April 26, 2016

**Re: HUB Apartments – Floor/Ceiling Assembly Review**

**Figure 1 – Propose Alternate Assembly.**

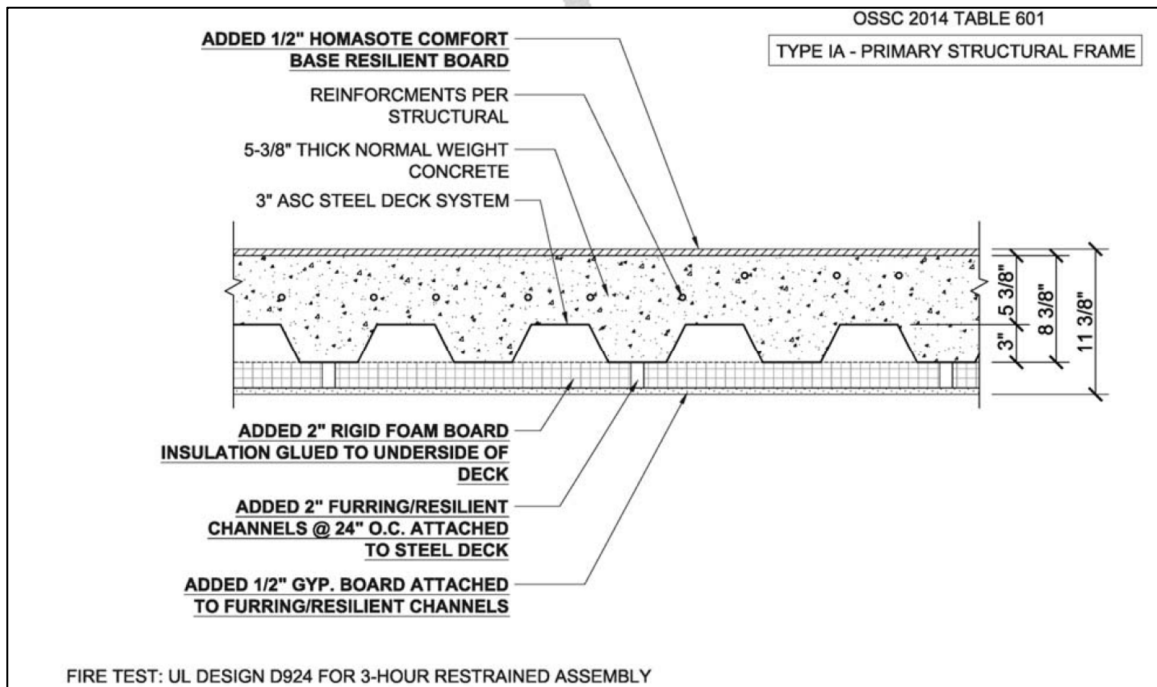
We note that the assembly indicates 2" furring/resilient channels in lieu of standard 7/8" resilient channels as well as 2" rigid foam insulation. We understand that based on the depth of 2", rigid channels will be used.

The Proposed Alternate has 5-3/8" concrete topping on a 3" metal deck and (1) layer 1/2" gypsum wallboard on 2" furring channel. Assuming normal-weight concrete, we estimate the mass of the concrete to be a minimum of 75 psf. With the 2" furring channel rigidly attached to the deck and rigid insulation in the cavity, the increase in STC due to the 1/2" layer of gypsum would be minimal since the concrete dominates the STC performance of the assembly. Based on this we rate the Proposed Assembly to have an STC 53-54.

Given that there is no tested assembly with the current version of Homasote ComfortBase that is installed with mechanical fasteners, we estimate the IIC of the Proposed Alternate to be similar to a 6" thick concrete slab with the 1/2" gypsum wallboard and rigid foam insulation in the cavity to be at IIC 29.

To increase the IIC above 50, we recommend one of the following acoustical underlayments that can be used with Luxury Vinyl Tile. These underlayments were tested on a 6" slab with a surface weight of 75 psf similar to the estimated weight of the Proposed Alternate assembly. The IIC rating and test numbers are included with each product.

- Jumpax by Sound Seal – IIC 51 (Intertek 3169380CRT-002b)
- Isolymt QT-F05 by Kinetics Noise Control – IIC 53 (NGC 7007066)
- RST-05 by Pliteq – IIC 53 (NRCC B3498.2)

Adding a layer of 1/2" gypsum wallboard attached to the deck with a 25 gauge channel and unfaced batt insulation in the cavity will only increase the STC and IIC ratings above the ratings listed in the previous sections.

We have reviewed laboratory tested assemblies that closely match the Proposed Alternate assembly. We rate the assembly at STC 53-54 and a minimum of IIC 51 with the appropriate underlayment.
